**HISTORIC LANDMARK COMMISSION
DECEMBER 16, 2013
NATIONAL REGISTER HISTORIC DISTRICT
NRD-2013-0072
Old West Austin
1415 Ethridge Avenue**

Demolish a non-contributing house and construct a new 3,980 sq. ft. house.

ROOF PLAN
SCALE 1/8" = 1'-0"

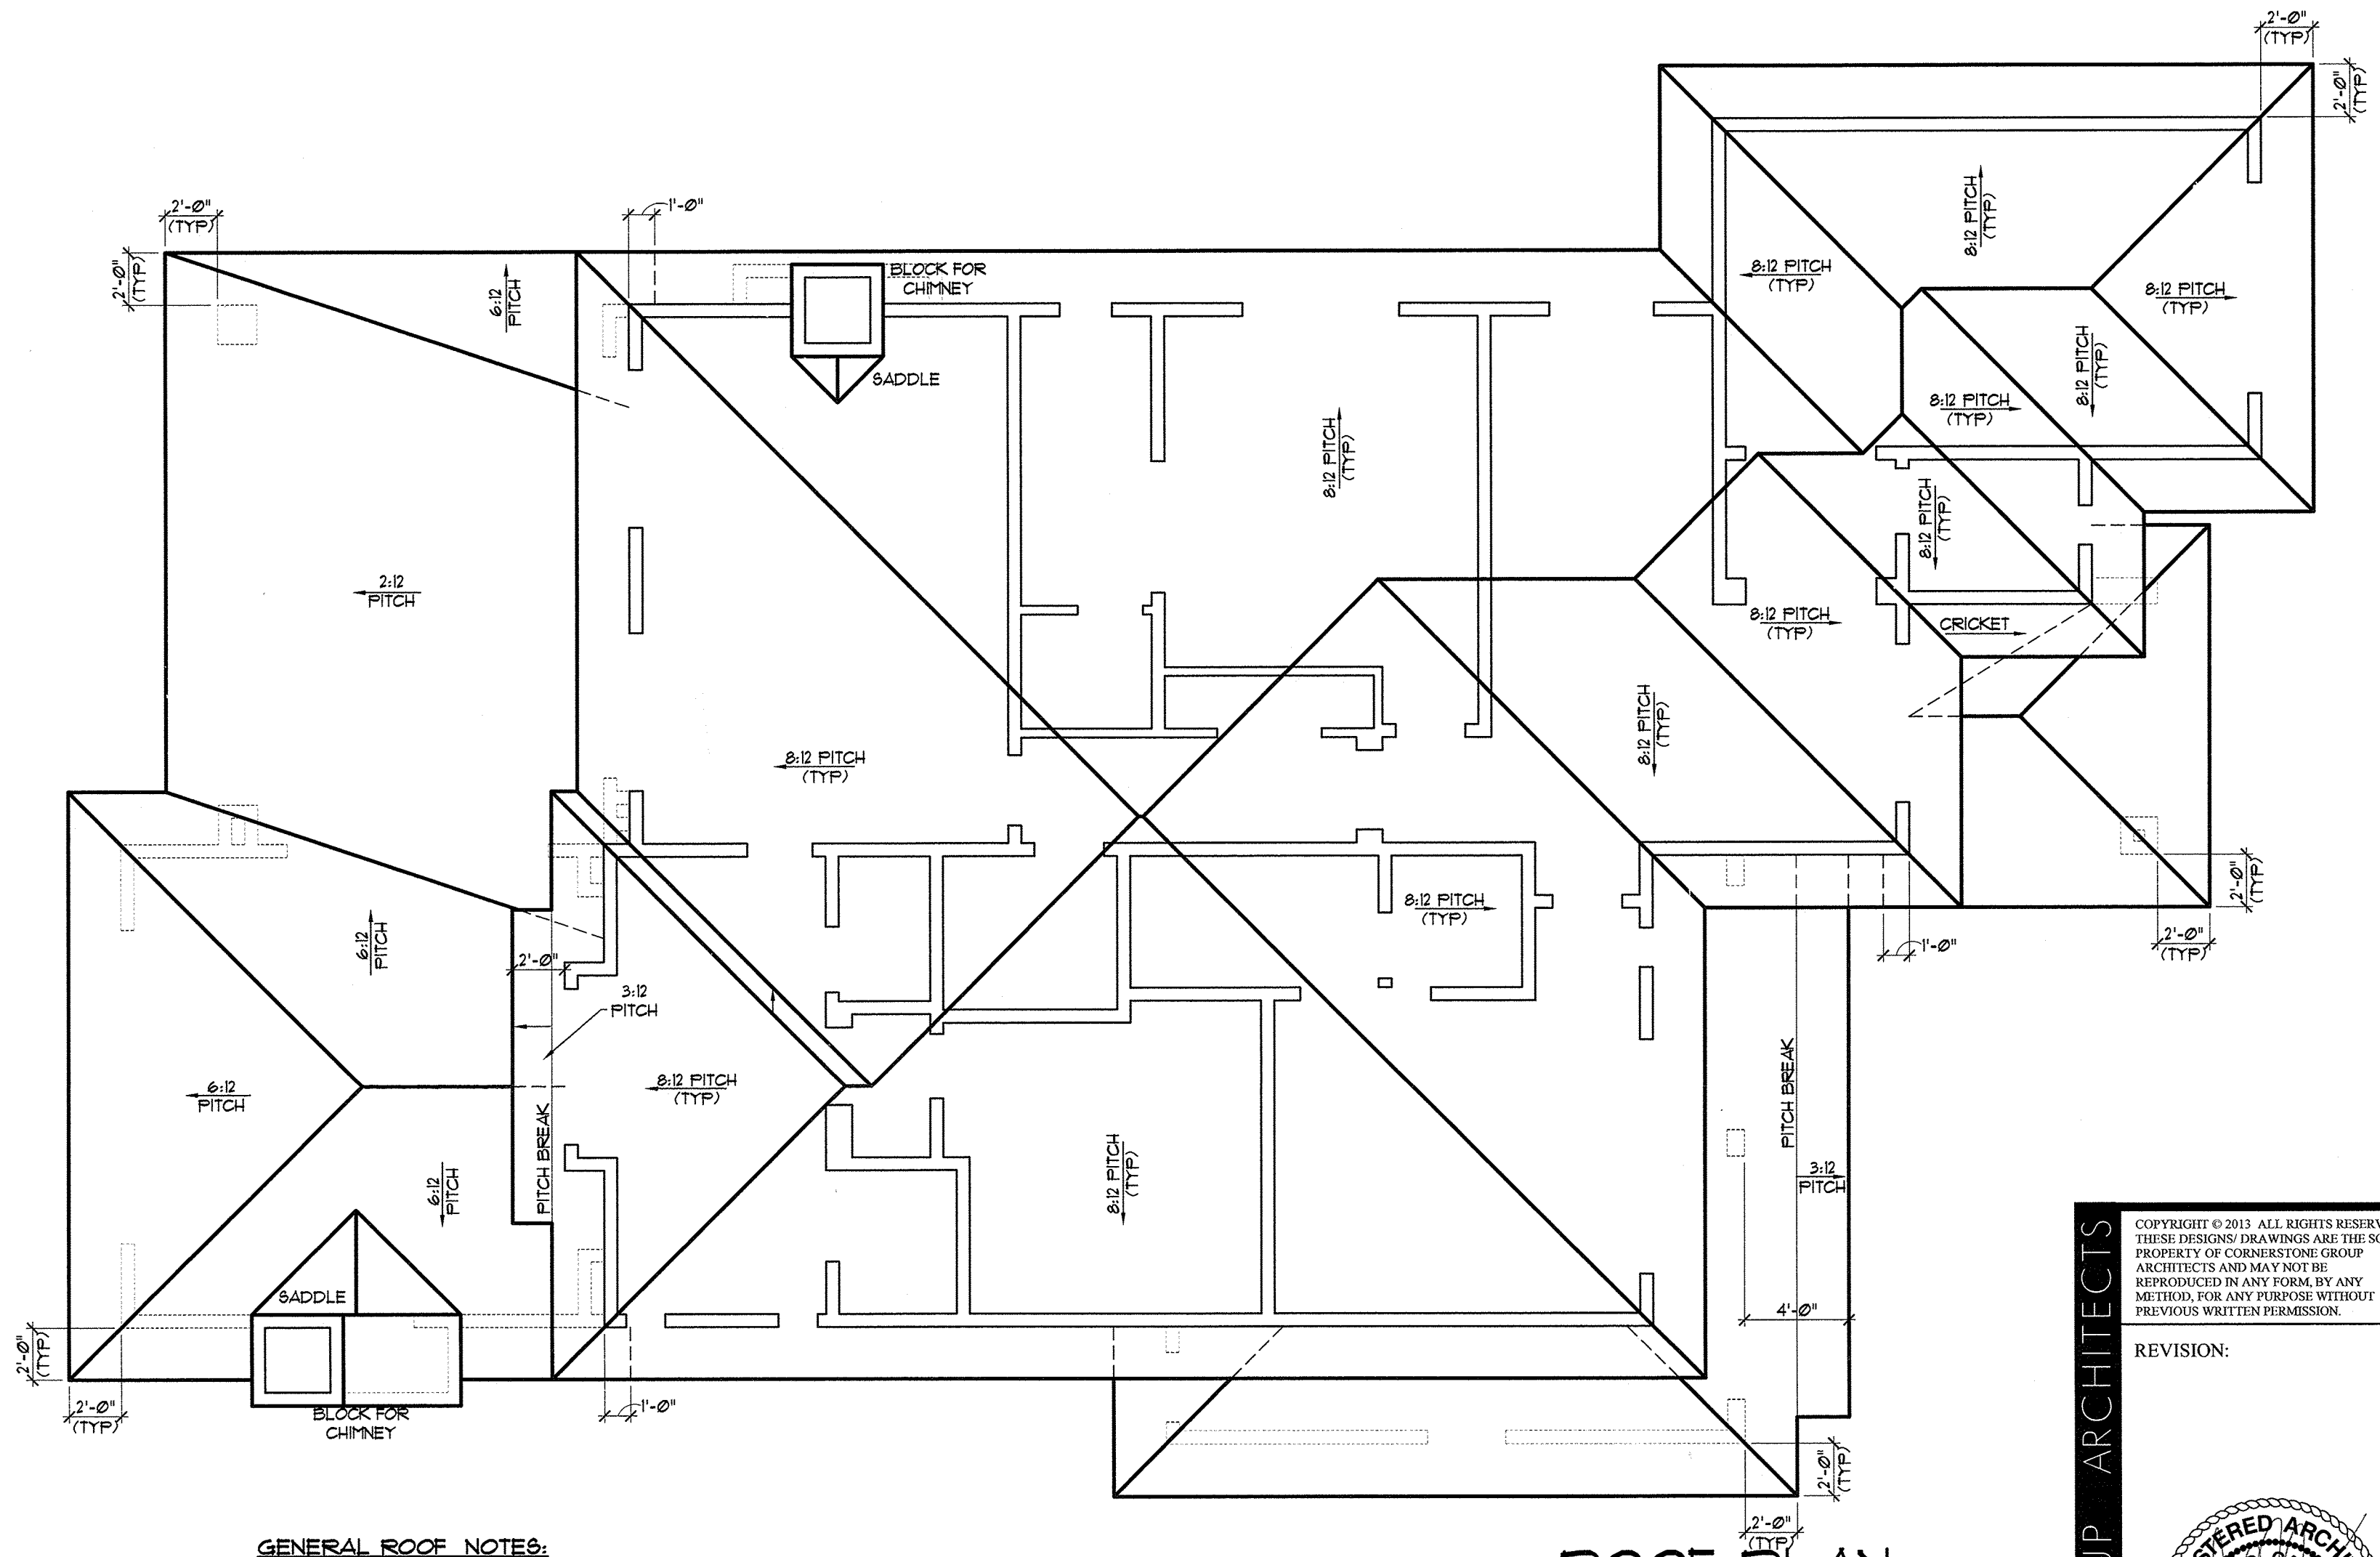
Most of the properties on this block of the District have large, two-story houses, some with front facing, attached garages. Although the design is contemporary, the scale, massing, and materials are generally compatible with other properties in the area of the District. However, the multiple hip roofs do not reflect the architectural form of either contributing or non-contributing properties on the block, most of which have more simple side gable or hip roofs.

Release the permit per the proposed design with the recommendation that the applicant simplify the roof form.
